**Pacific Gas and
Electric Company**

PG&E Letter DCL-02-019

Docket No. 50-275, OL-DPR-80
Docket No. 50-323, OL-DPR-82
Diablo Canyon Units 1 and 2
Response to NRC Request for Additional Information Regarding Supplement 3 to
License Amendment Request 00-06, "Alternate Repair Criteria for Axial PWSCC at
Dented Intersections in Steam Generator Tubing"

**PG&E Response to NRC Request for Additional Information Regarding
Supplement 3 to License Amendment Request 00-06, "Alternate Repair Criteria
for Axial PWSCC at Dented Intersections is Steam Generator Tubing"**

Figure 2. Pancake 80 mil Coil Vertical Amplitude Strip Charts for Axial and Circumferential EDM Notches.

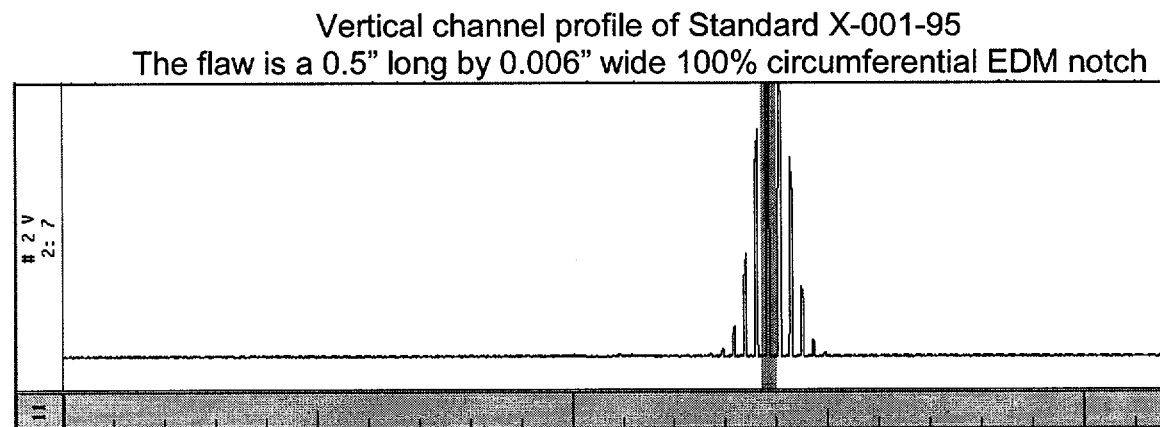
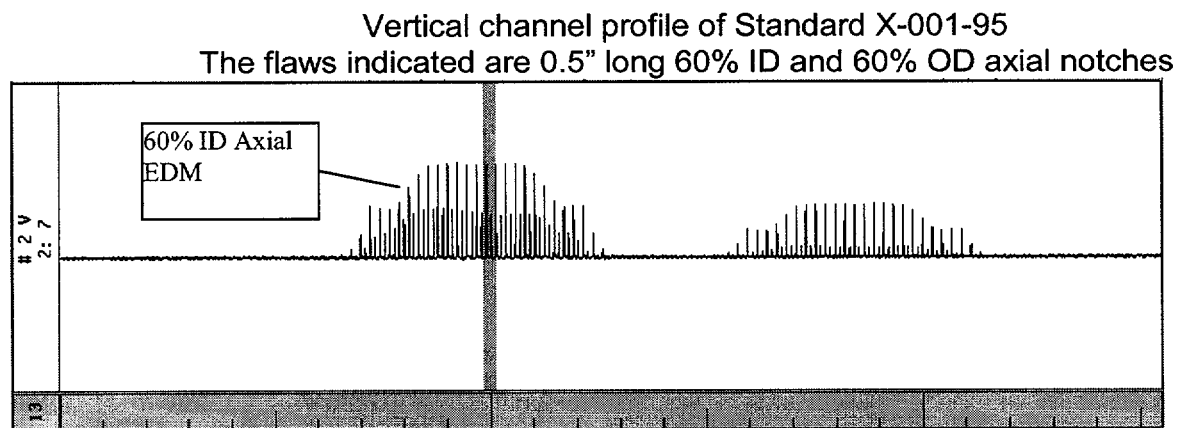
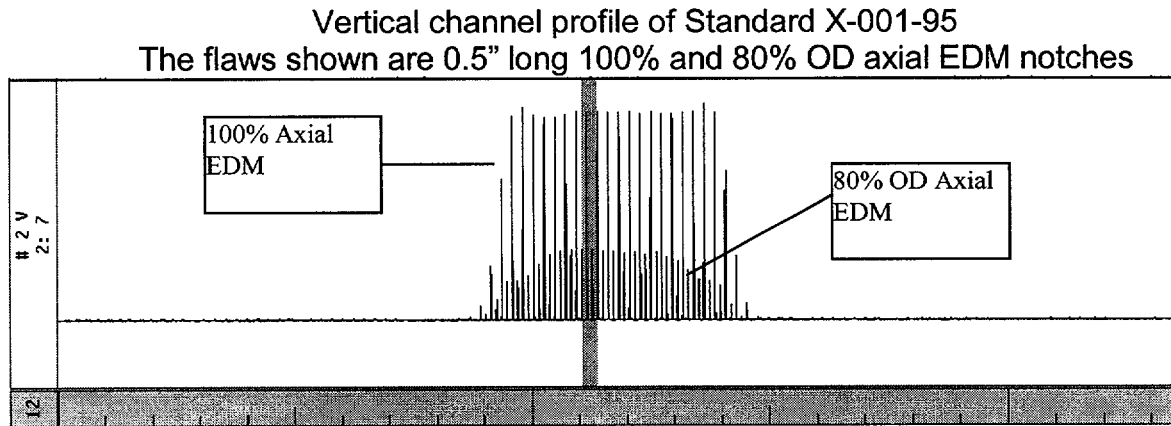
Figure 4-28 in which vertical amplitude response from an axial through wall and an 80% OD EDM notch are compared shows the data at a frequency of 300 kHz. However, the proposed NDE method for determination of the separation distance between mixed mode cracks is based on analyzing the data at a frequency of 600 kHz. Therefore, please provide either this Figure displaying the data at a frequency of 600 kHz or a brief explanation of the difference in frequency.

Figure 2 of this letter provides the data of Figure 4-28 of WCAP-15573, Revision 1, displayed at a frequency of 600 kHz.
